ALASKAN WAY VIADUCT

EVALUATION OF GRAY'S RETROFIT PROPOSAL

Prepared for the
Washington State Department of Transportation

By
T.Y. Lin International

Figure D.10a Floorbeam curvature ductility demand, retrofitted structure, rare earthquake, upper level

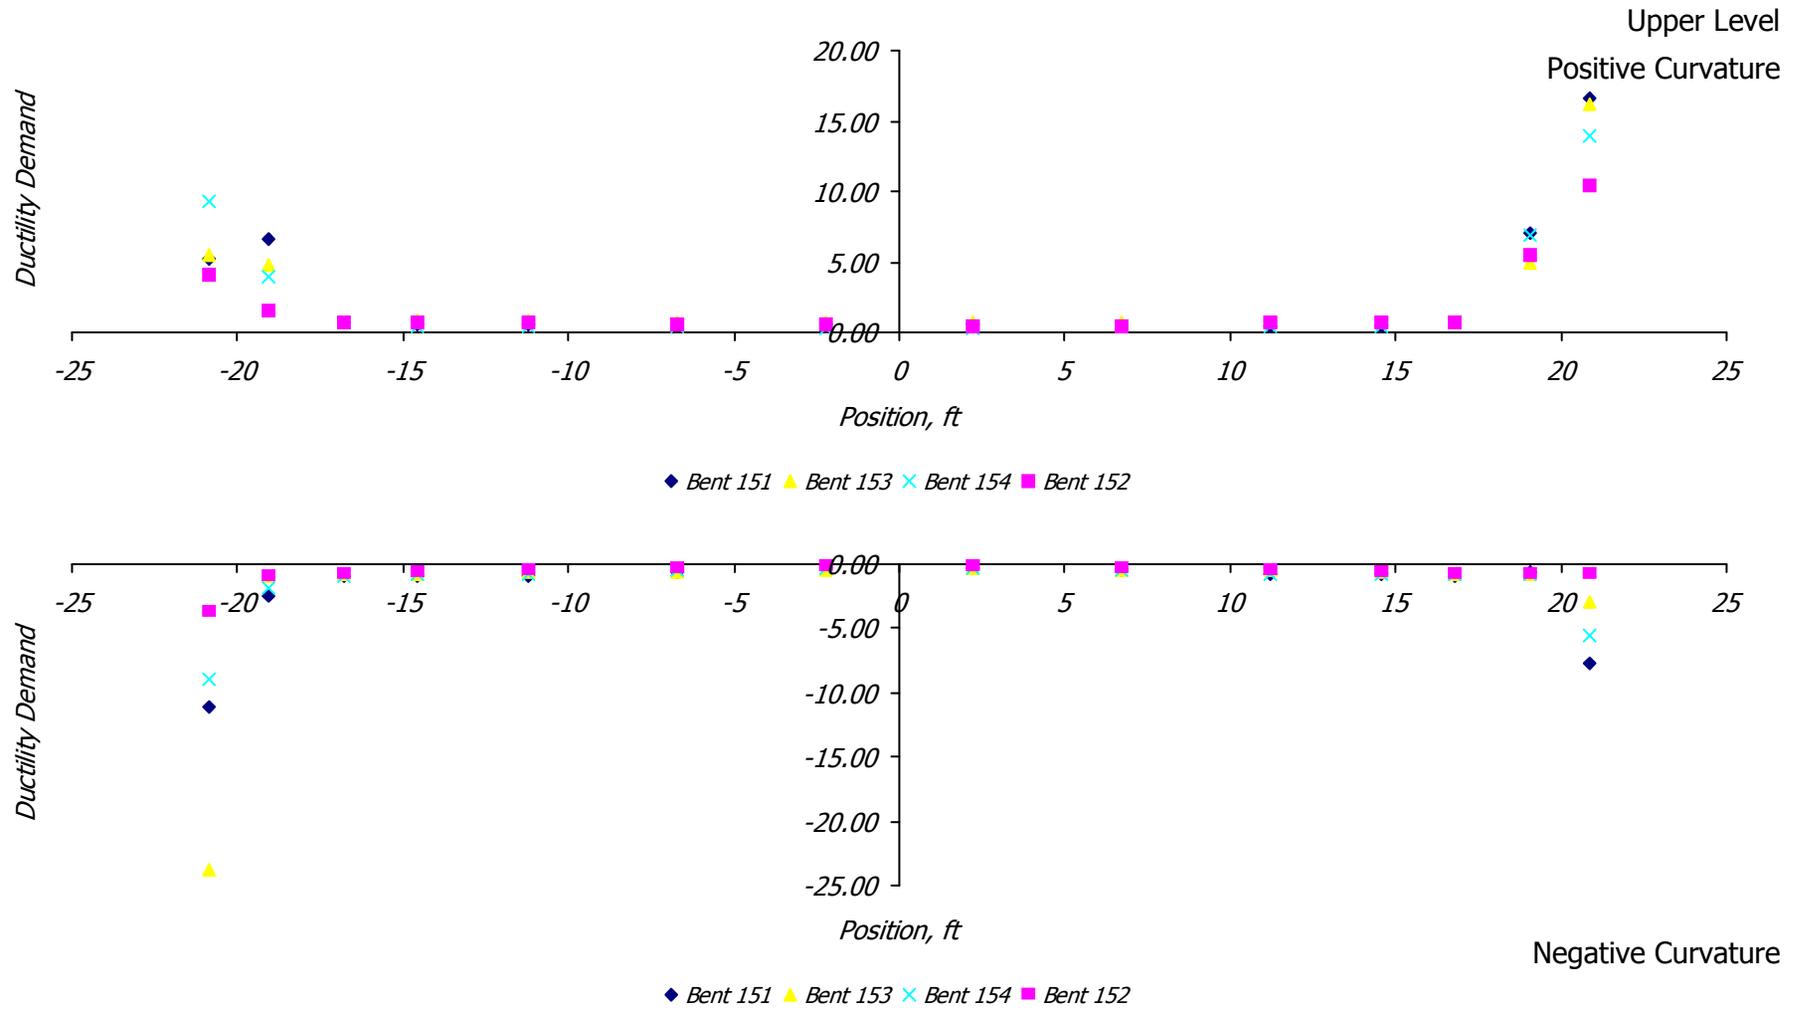
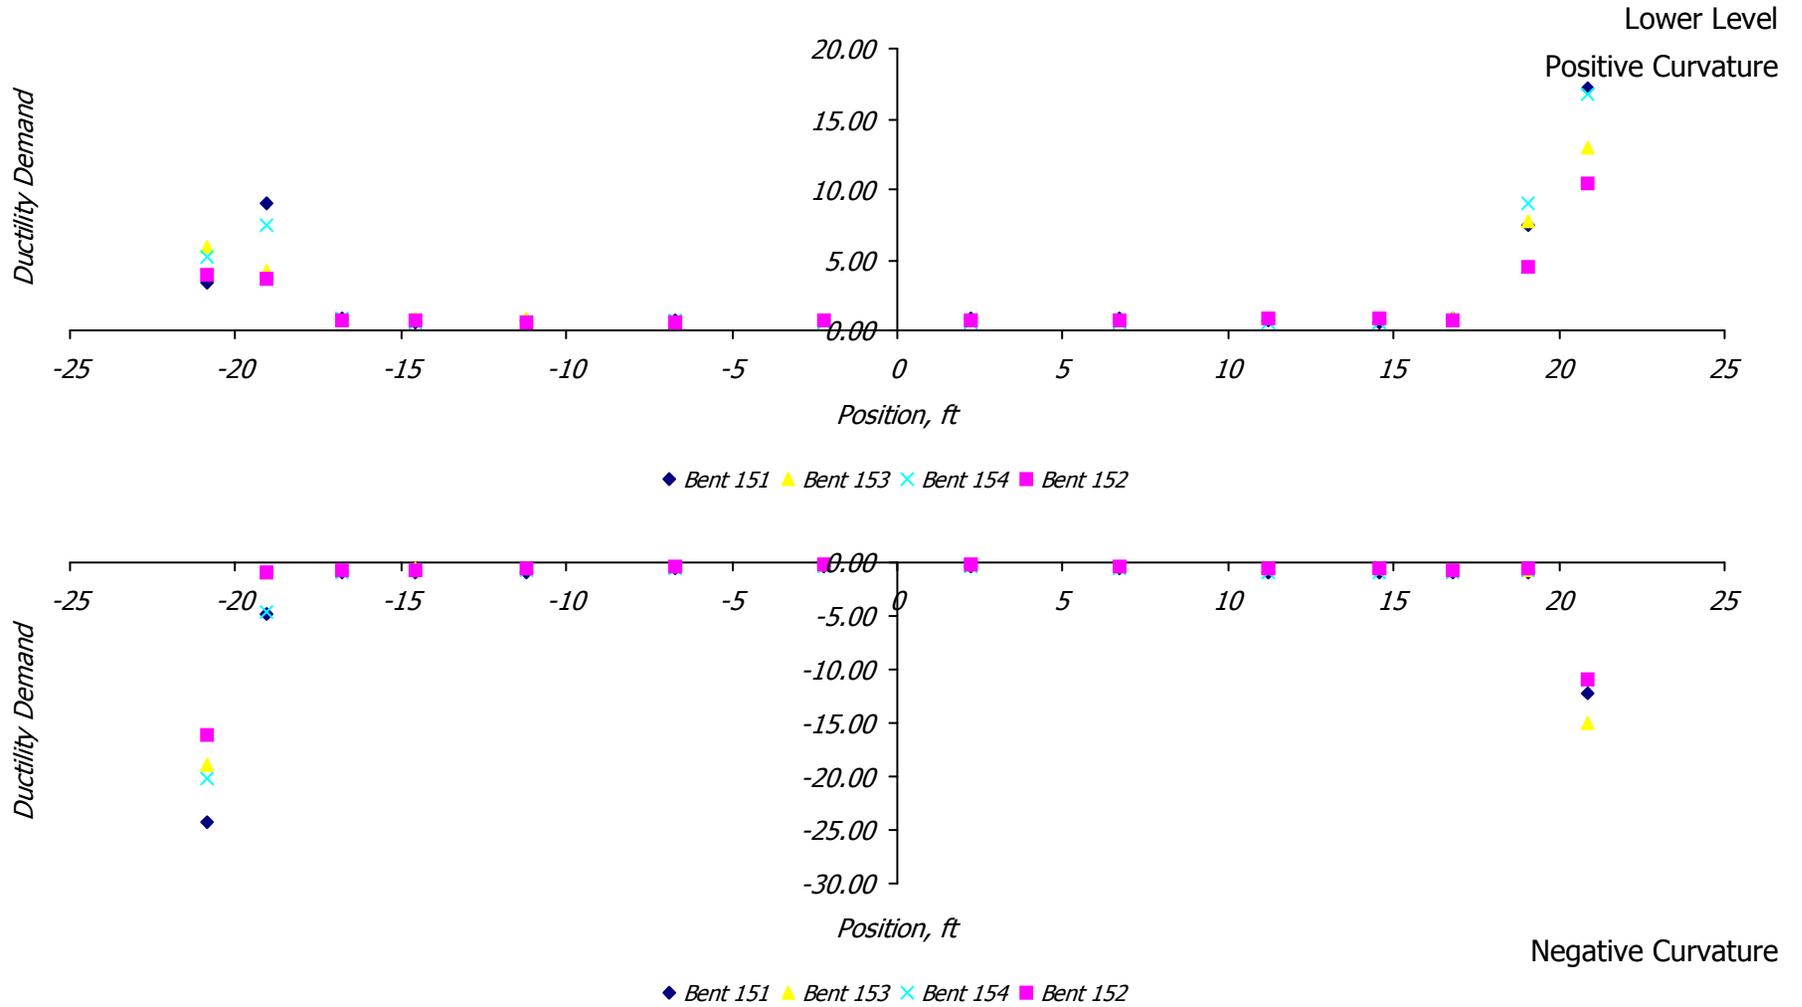
For the rare earthquake, the curvature ductility demands on the floorbeams are summarized in Figure D.10. There are separate plots for the upper and lower level floorbeams, and positive (\cup) and negative (\cap) demands are plotted separately. The plots show that plastic hinges form at the faces of the columns.

Figure D.11b Floorbeam curvature versus axial force, retrofitted structure, rare earthquake, lower level

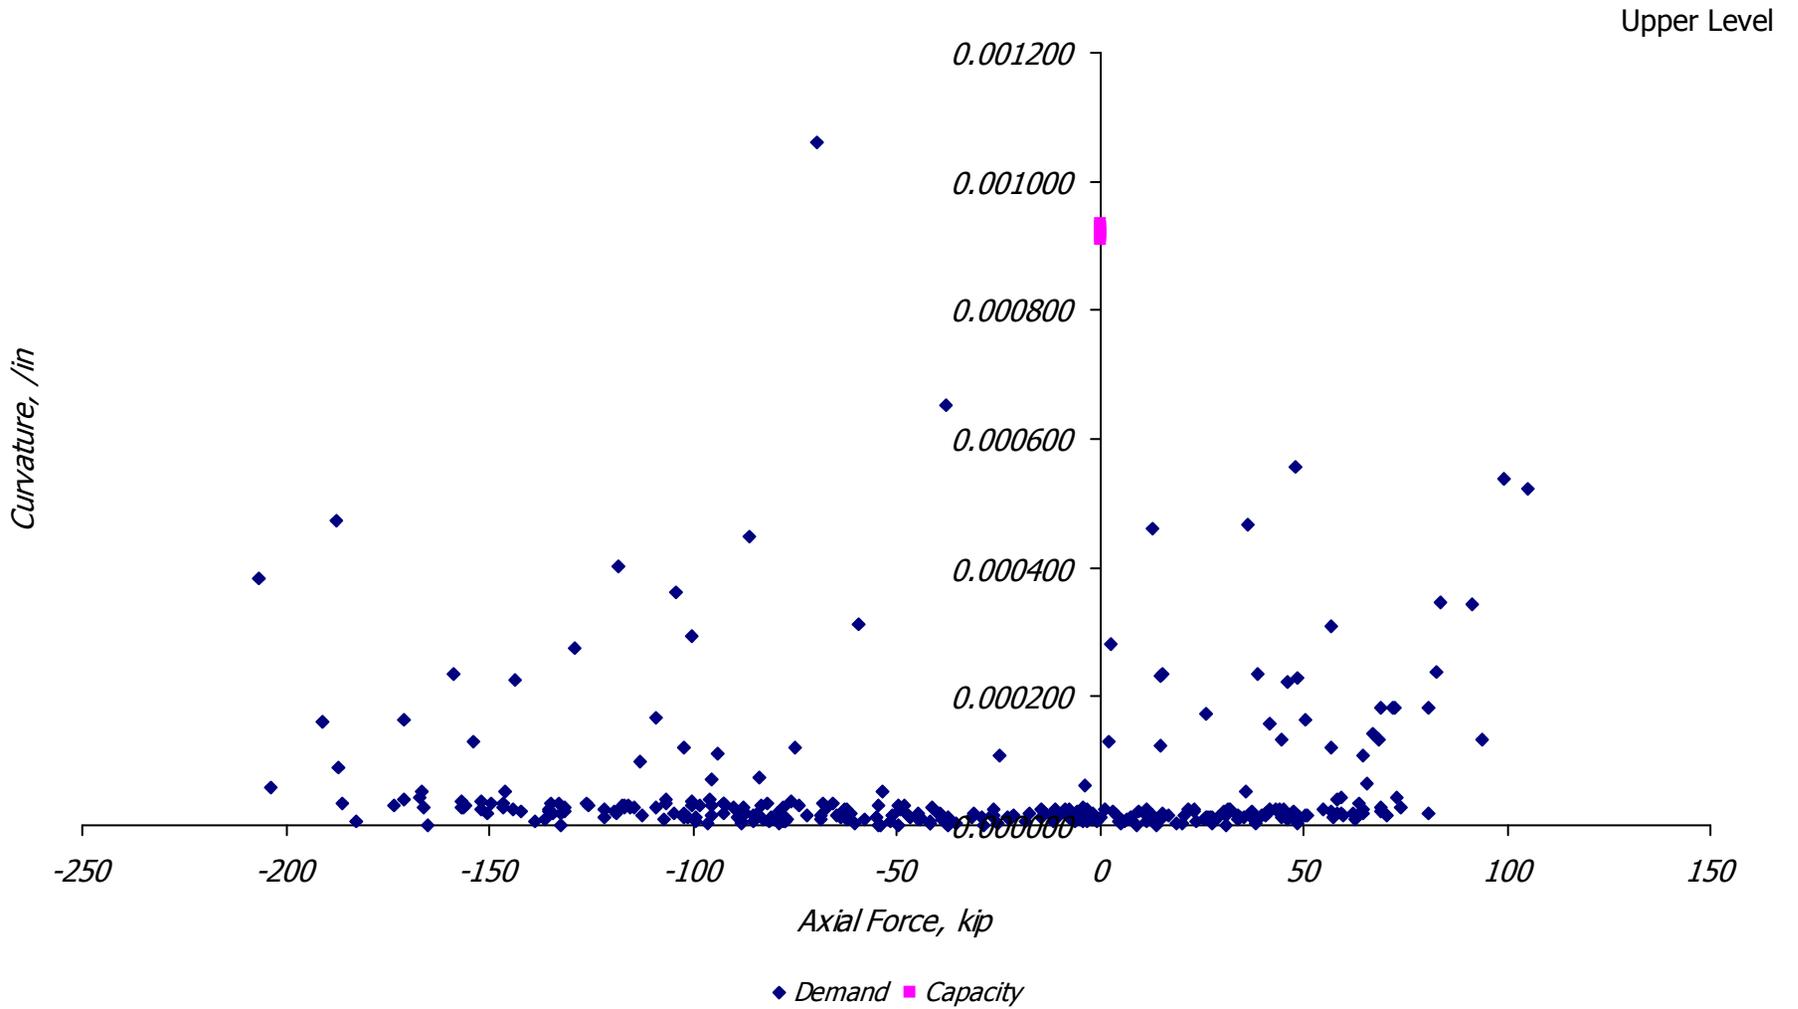
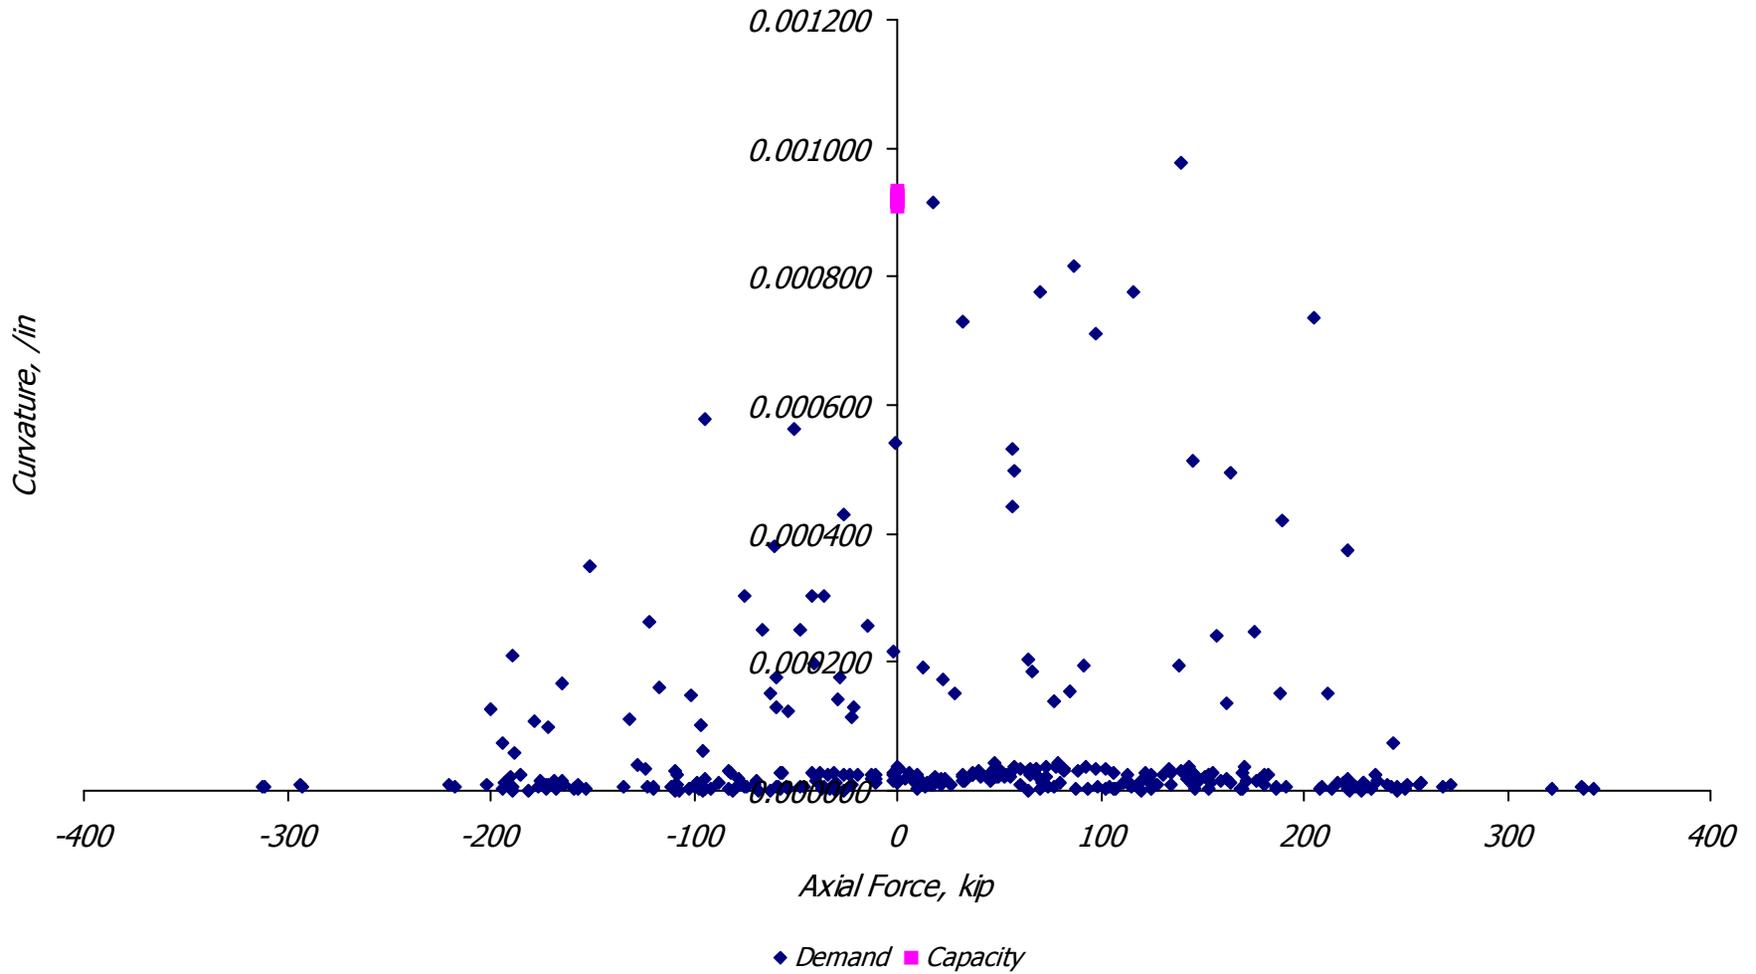
Plots of simultaneous curvature and axial force demands on the floorbeams are shown in Figure D.11; there are separate plots for the upper and lower level floorbeams. The capacity curves are represented by clusters of points along the curvature axes (for axial forces of zero). This is because the capacities of the various floorbeams sections are nearly the same, and because the capacity was only calculated for an axial force of zero (because the axial forces in the floorbeams are modest).

Figure D.11 indicates that the floorbeams will fail in flexure—in negative bending near one of the columns. This same failure was predicted by the pushover analysis described previously. A demand/capacity ratio of 1.08 was obtained for the middle bents from that analysis. A similar ratio may be inferred from Figure D.11b.

Figure D.12a Floorbeam curvature ductility demand, retrofitted structure, design earthquake, upper level

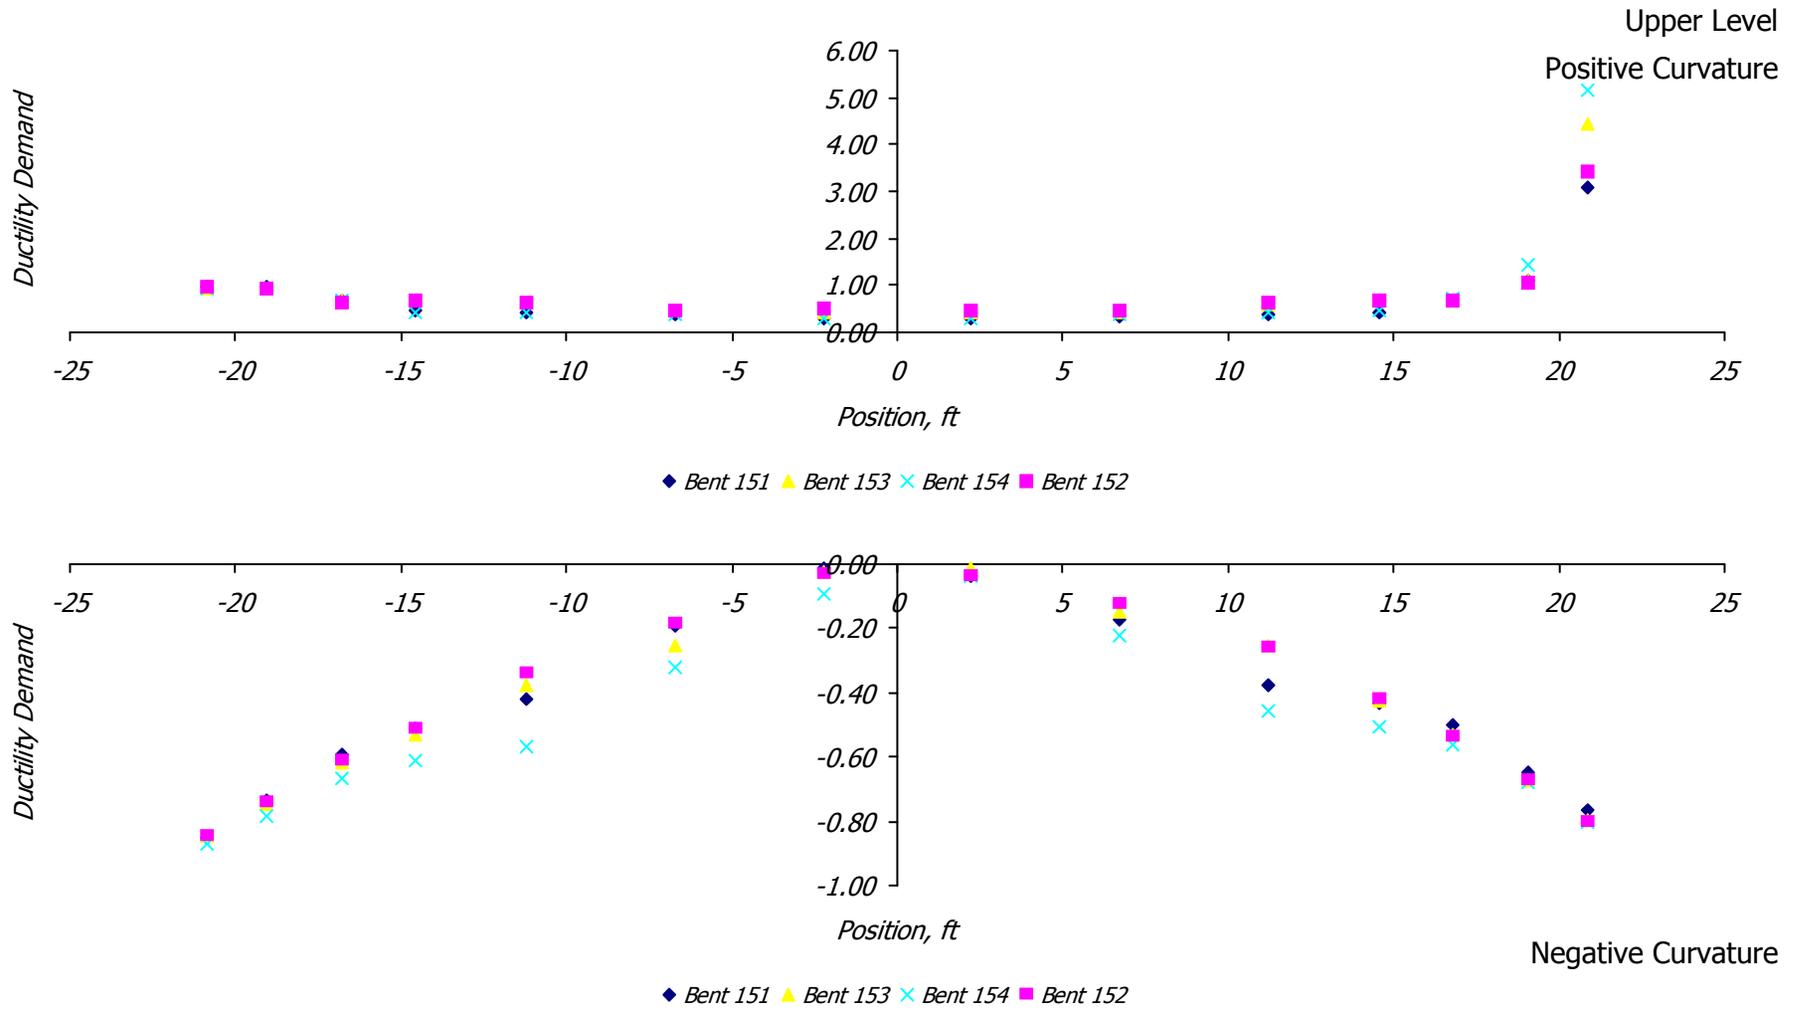
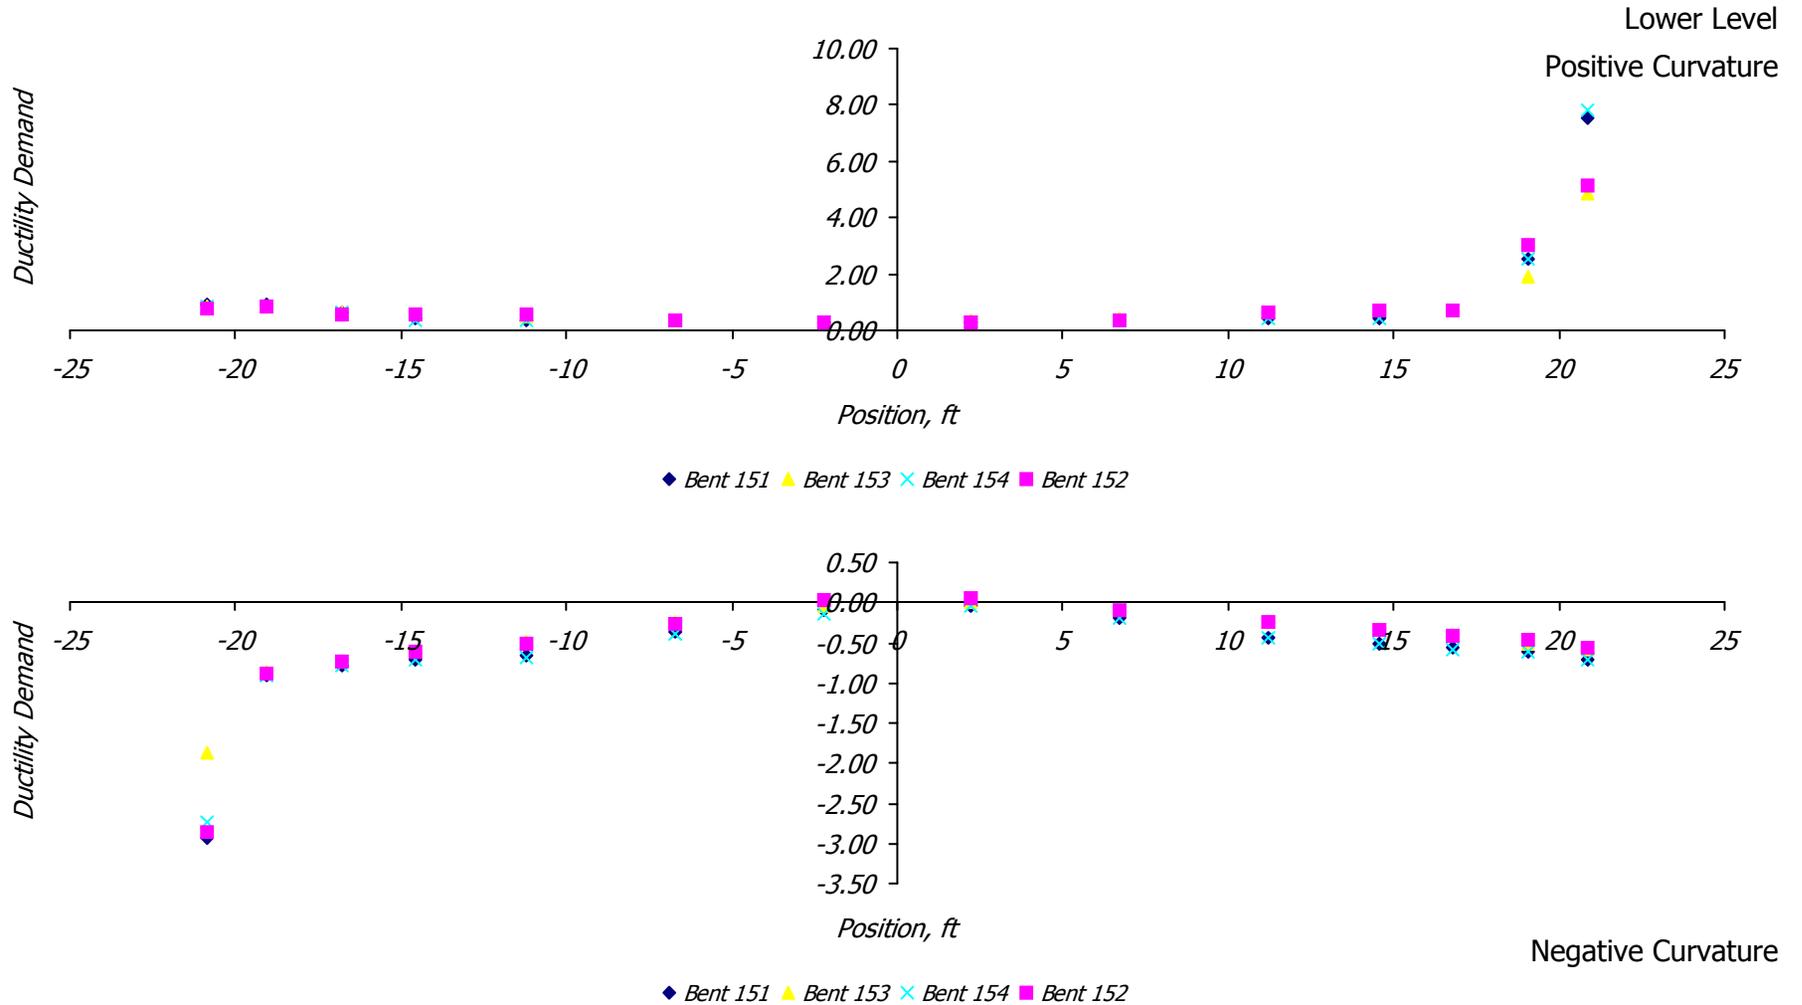
For the design earthquake, the curvature ductility demands on the floorbeams are summarized in Figure D.12. The largest demands are large enough to cause significant cracking and yielding of reinforcement, but within the limits for repairable damage provided that there is not major degradation in development of reinforcing details.
